# Access Compliance Report

## Public Rights-of-Way

Intersection ID: 22459	Main Street: BELLEVUE_LN	Cross Street: MOORELAND_FARMS_RD	Location: S
ADA ID: 028A454D6D28	Ramp Type: PerpDiag	Initial Pass/Fail: Fail	Overall Compliance: No
		Severity Score: 10

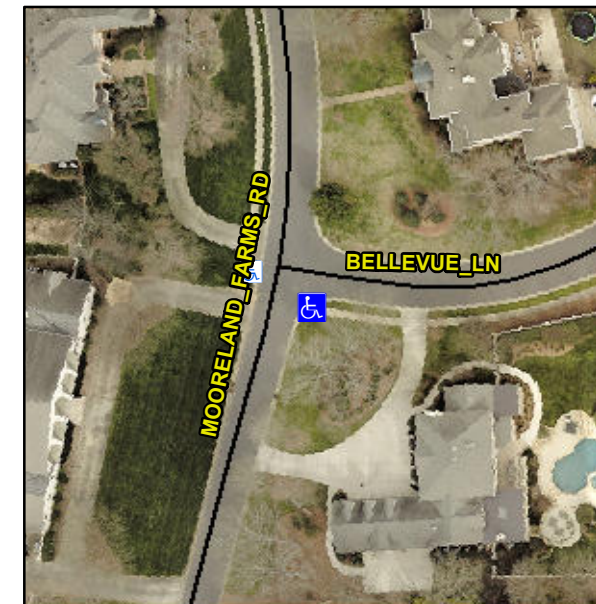
**R304.5.1, R304.5.3**

Compliance	Description	Data	Compliance	Description	Data
N/A	Ramp Length (in)	43.0	Yes	Ramp Slope (%)	7.9
No	Ramp Width (in)	47.0	No	Ramp XSlope (%)	2.9
N/A	Flare Type LT	N/A	N/A	Flare Type RT	N/A
N/A	Flare Slope LT (%)	N/A	N/A	Flare Slope RT (%)	N/A
N/A	Flare Traversable LT?	N/A	N/A	Flare Traversable RT?	N/A
N/A	Landing Length (in)	N/A	N/A	DWS Provided?	N/A
N/A	Landing Width (in)	N/A	N/A	DWS Contrast?	N/A
N/A	Landing Slope (%)	N/A	N/A	DWS Length (in)	N/A
N/A	Landing X Slope (%)	N/A	N/A	DWS Full Width?	N/A
N/A	Landing Curb? (Y/N)	N/A	N/A	DWS Offset (in)	N/A
N/A	Shared Landing?	N/A			
N/A	Gutter Ponding?	N/A	N/A	Gutter Slope (%)	N/A
N/A	Gutter Lip Ht (in)	N/A	N/A	Gutter X Slope (%)	N/A
N/A	Painted X Walk1?	No	N/A	Painted X Walk2?	No
	X Walk 1 Direction	To NE		X Walk 2 Direction	To NW
N/A	X Walk 1 Width (in)	N/A	N/A	X Walk 2 Width (in)	N/A
	X Walk 1 Slope (%)	4.1		X Walk 2 Slope (%)	3.0
	X Walk 1 X Slope (%)	3.8		X Walk 2 X Slope (%)	0.7

**Remove & Replace Curb Ramp With Two New Directional Ramps or Equivalent.**
